# United States Patent and Trademark Office

APPLICATION NO.	FILING DATE	FIRST NAMED INVENTOR	ATTORNEY DOCKET NO.	CONFIRMATION NO.	
10/695,160	10/29/2003	Howard E. Rhodes	M4065.0939/P939	M4065.0939/P939 7143	
24998 759	7590 11/23/2005		EXAM	EXAMINER	
DICKSTEIN S	SHAPIRO MORIN & O	HO, TU	HO, TU TU V		
2101 L Street, NW			ART UNIT	PAPER NUMBER	
Washington, Do	Washington, DC 20037				
			2818 DATE MAILED: 11/23/2005

Application No.	Applicant(s)			
	10/695,160	RHODES, HOWARD E.			
Office Action Summary	Examiner	Art Unit			
	Tu-Tu Ho	2818			
The MAILING DATE of this communication app	<u> </u>				
Period for Reply  A SHORTENED STATUTORY PERIOD FOR REPLY THE MAILING DATE OF THIS COMMUNICATION.  - Extensions of time may be available under the provisions of 37 CFR 1.13 after SIX (6) MONTHS from the mailing date of this communication.  - If the period for reply specified above is less than thirty (30) days, a reply - If NO period for reply is specified above, the maximum statutory period w - Failure to reply within the set or extended period for reply will, by statute, Any reply received by the Office later than three months after the mailing earned patent term adjustment. See 37 CFR 1.704(

Note: Numerical Reference 280 added by the examiner for ease of explanation

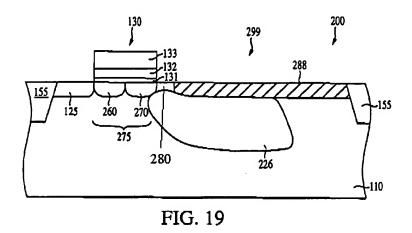
The '799 reference discloses in the figures, particularly Fig. 19, and respective portions of the specification a photoconversion device as claimed.

Referring to claim 30, the '799 reference discloses a photoconversion device comprising: a substrate (110, Fig. 19) having a surface;

a first region (170 or 270) doped to a first conductivity type (p, Figs. 7-19, paragraphs [0075] to [0077]) located below the surface of the substrate;

a second region (280, Fig. 19, reference 280 added by the examiner for ease of explanation – and see details iso.1 in the 112 rejections above, i.e., the second region is *doped* - according to the

doping of the substrate similarly to the present invention or other means) laterally adjacent to said first doped region; and

a third region (126 or 226) doped to a second conductivity type (n, paragraph [0079]) (a portion of which third region is – and see details d.3 in the drawing objections above) located beneath said first doped region for collecting photogenerated charges (paragraph [0045]).

Referring to claim 34, the reference further discloses that said second region (280) does not have a dopant concentration of said first conductivity type.
